Wheel Horse Service Bulletins 1961 - 1990: **#126** Issued: November 1970  
**Service Replacement Electric Clutch - 1968-70 Electro and GT 14 Tractors**

Current production clutch, Part No. 101473, has also been released as the service replacement for Part Nos. 7915, 8278 & 9656 which were original equipment clutches on 1968-1970 Electro and GT 14 tractors. Special instructions for installing the new clutch are given below by original clutch number and tractor model.

#### CRANKSHAFT DRILLING INSTRUCTIONS - To replace #7915 clutch with #101473

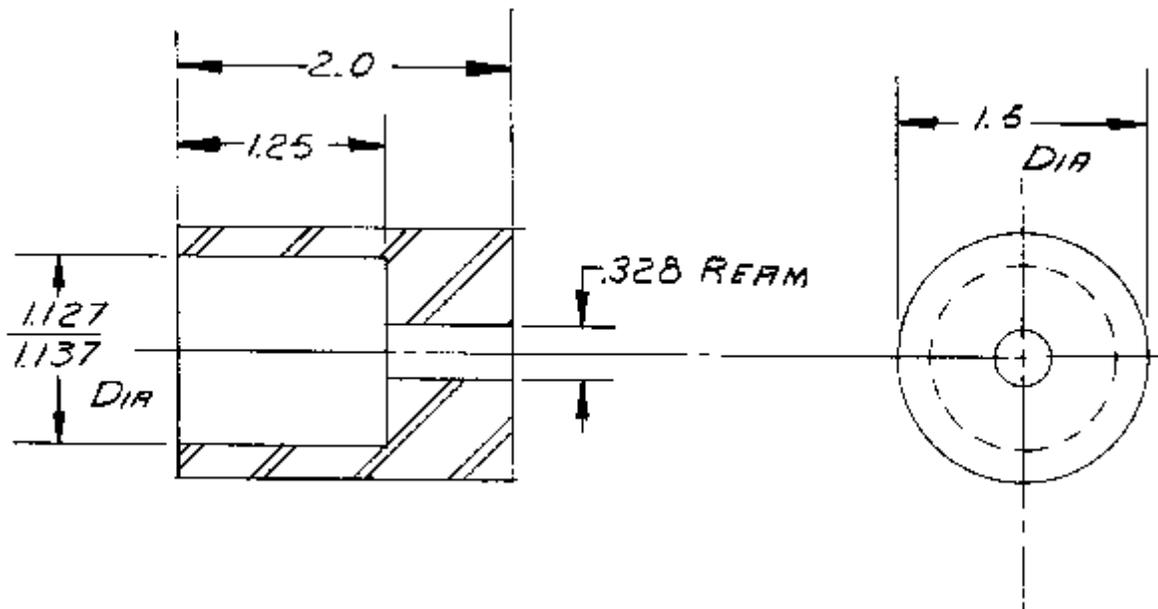
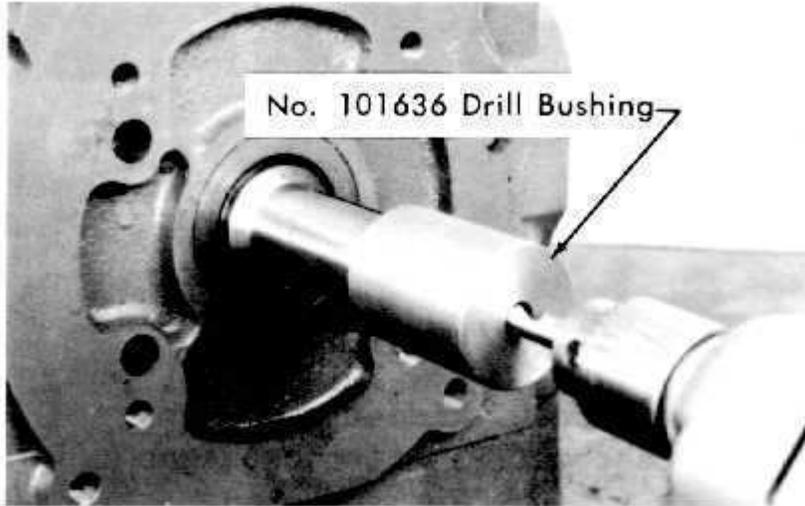
1. Remove electric clutch, engine pulley and crankshaft key.
2. Fit trill bushing on end of crankshaft and trill crankshaft to a depth of 1 3/8" with 5/16" dia. drill.
3. Tap hole 3/8-16 thread to a usable depth of 1".

The drill bushing illustrated here can be made up locally from the shop drawing reproduced below or purchased through your Wheel Horse distributor.

**Order Part No. 101636.**
